ADDENDUM NUMBER 1

GATEWAY PARK

September 7, 2021

CD-14.01

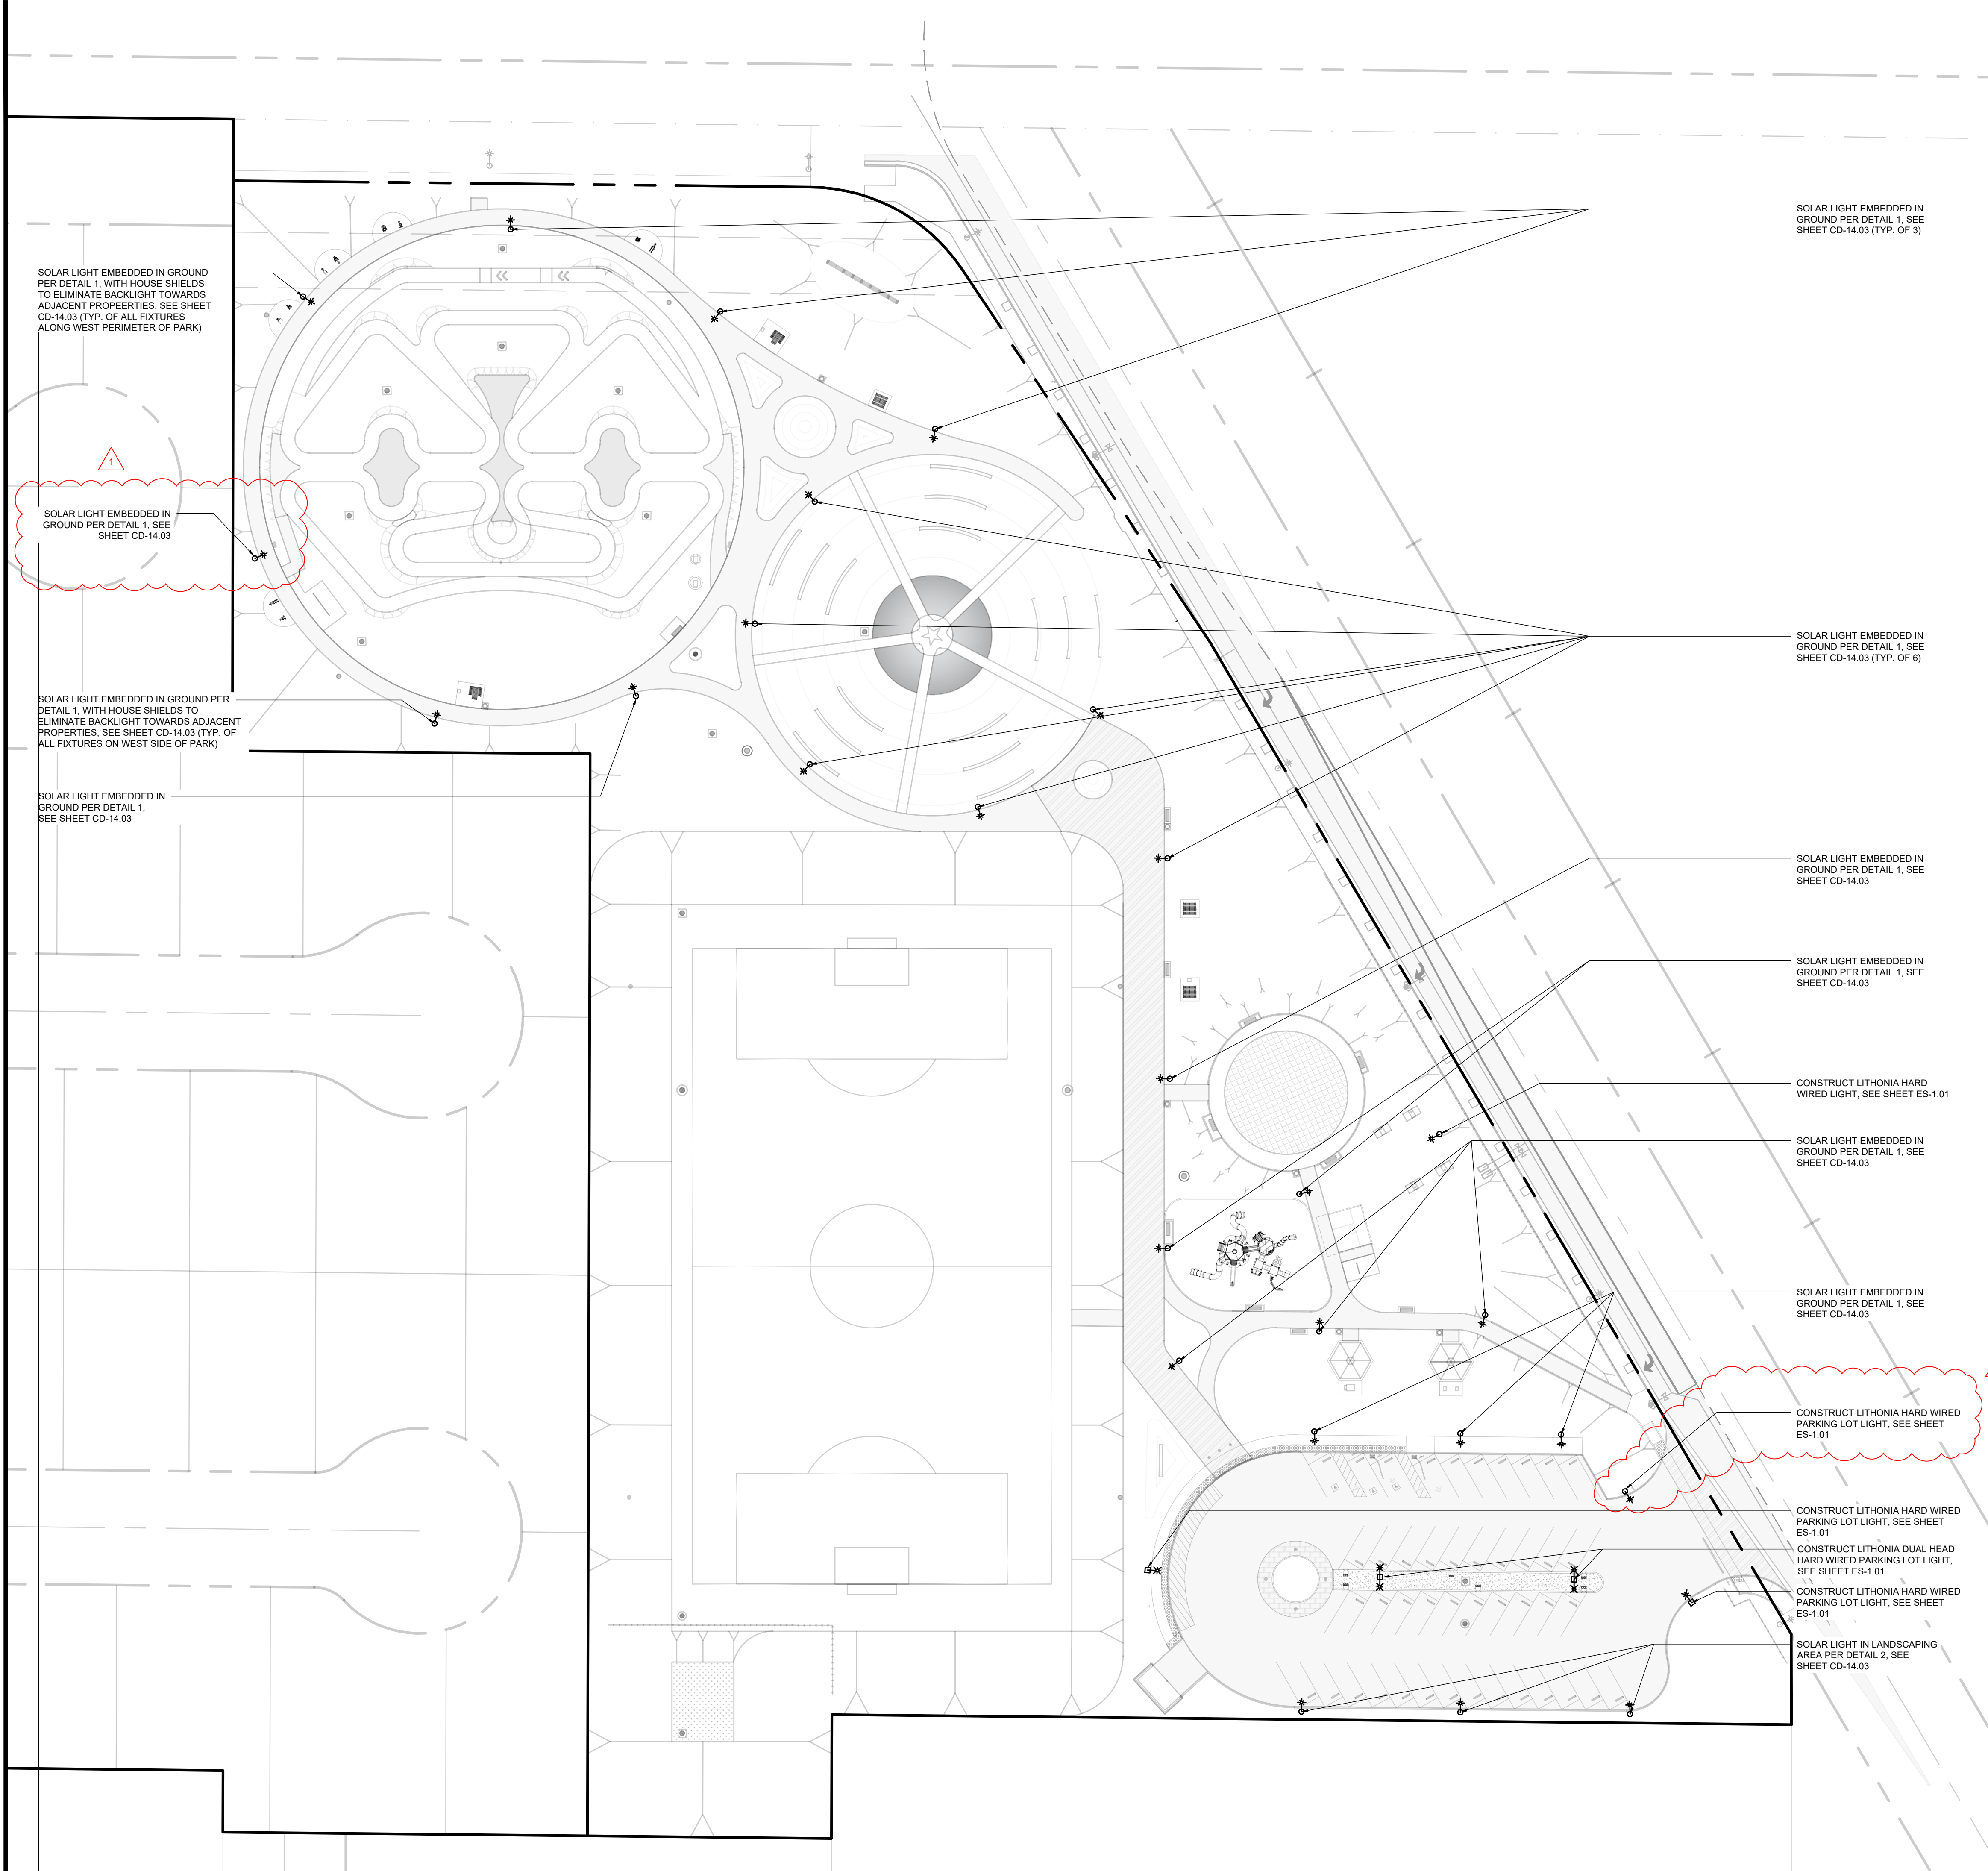
On sheet CD- 14.01 I counted 26 solar pole mounted light fixtures. Electrical drawing sheet ES-1.01 only shows 24 of the same light fixtures. Please advise as to which drawing sheet we should use to price this project.

Use a total of 25 solar mounted light fixtures as shown on the attached CD-14.01. Contractor shall coordinate electrical drawings with CD-14.01.
